UNITED STATES PATENT AND TRADEMARK OFFICE

APPLICATION NO.	FILING DATE	FIRST NAMED INVENTOR	ATTORNEY DOCKET NO.	CONFIRMATION NO.
10/090,371	03/04/2002	Dawei Huang	HUANG 2-1 (58655)	5175
46290	7590	09/16/2005	EXAMINER	
WILLIAMS, MORGAN & AMERSON/LUCENT 10333 RICHMOND, SUITE 1100 HOUSTON, TX 77042			TORRES, JOSEPH D	
			ART UNIT	PAPER NUMBER
			2133

Office Action Summary	Application No. 10/090,371	Applicant(s) HUANG ET AL.	
	Examiner Joseph D. Torres	Art Unit 2133

DETAILED ACTION

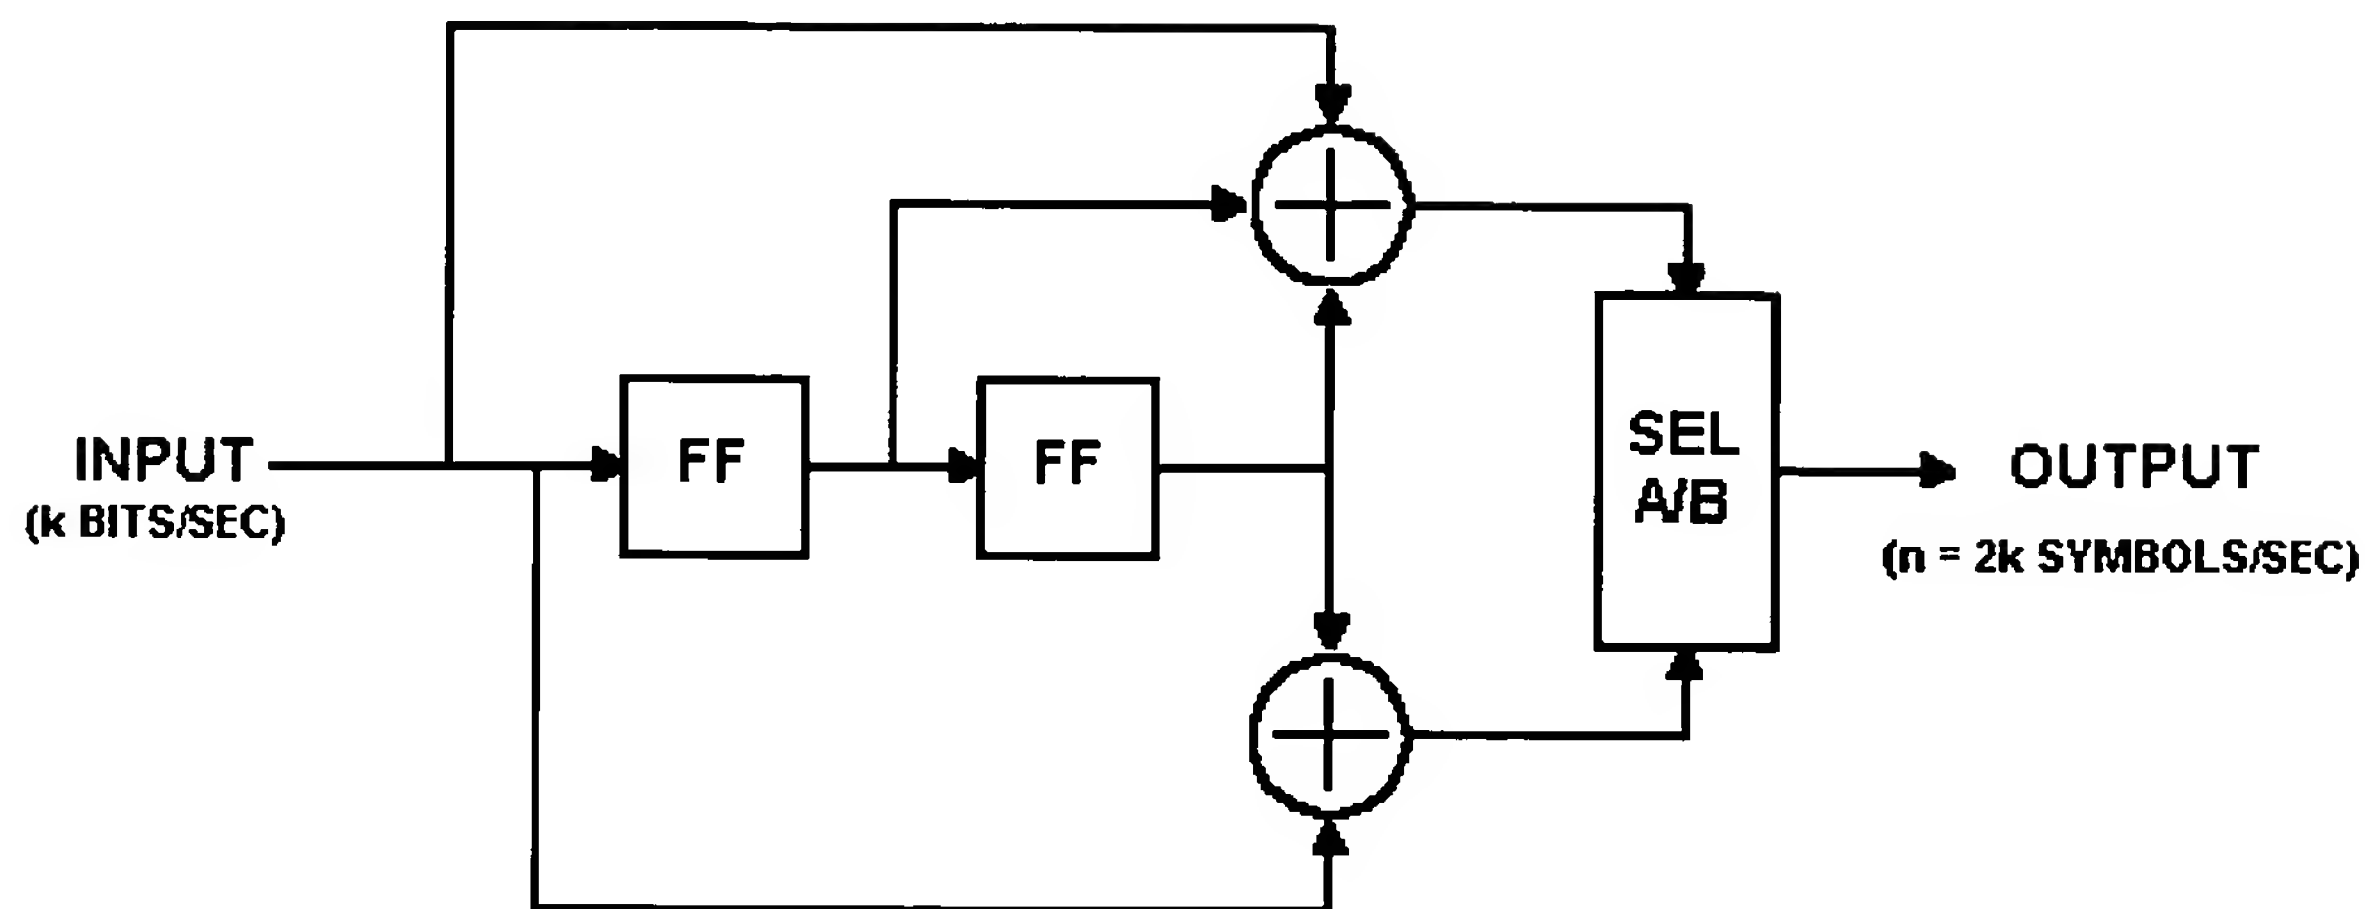
Based on the Examiner's understanding, what does a "time varying convolution code" have to do with the all zero code (e.g. $c=00000...0000$ or $C=\{00000...0000\}$).

The Examiner disagrees and asserts that claim 17 recites receiving a digital input data sequence; periodically inserting known symbols into the digital input data sequence and forming an expanded digital input data sequence based on a constraint length $k=m-1$, wherein m corresponds to a memory length and a code rate is $R=1/l$, such that the known symbols are inserted after each $k-1$ information bit; and trellis encoding the expanded digital input data sequence to produce a channel coded data stream wherein the number of connections between trellis nodes in a trellis are reduced. If Examiner 1 writes a digital input data sequence $s = [0110]$ on a piece of paper and gives the piece of paper to Examiner 2, then Examiner 2 receives a digital input data sequence $s = [0110]$ on a piece of paper. The constraint length of the convolutional encoder in the Figure below is $K= m-1=1$, Examiner 2 can write on the same paper the expanded sequence $es = [00101000]$ by periodically inserting a zero every other bit which is a step carried out by hand for periodically inserting known symbols into the digital input data sequence $s = [0110]$ and forming an expanded digital input data sequence $es = [00101000]$ based on a constraint length $k=m-1=1$, wherein m corresponds to a memory length of the convolutional encoder in the Figure below and a code rate is $R=1/l$ whereby $l=2$, such that the known symbols are inserted after each $k-1=1$ information bits.

Examiner 2 can apply the expanded digital input data sequence $es = [00101000]$ to the Figure, above by visually and hand and to produce an encoded output $ces = [00\ 00\ 11\ 10\ 00\ 10\ 11\ 00]$ which is a step carried out by hand for trellis encoding the expanded digital input data sequence $es = [00101000]$ to produce a channel coded data stream $ces = [00\ 00\ 11\ 10\ 00\ 10\ 11\ 00]$ wherein the number of connections between trellis nodes in a trellis are reduced.

The algorithm presented in claim 17 requires no hardware and can hardly be considered useful when carried out by hand especially when long complex codes and codeword are used (the data would probably be obsolete by the time it was encoded by hand). As such the Examiner maintains that claims 10-22 are non-statutory.
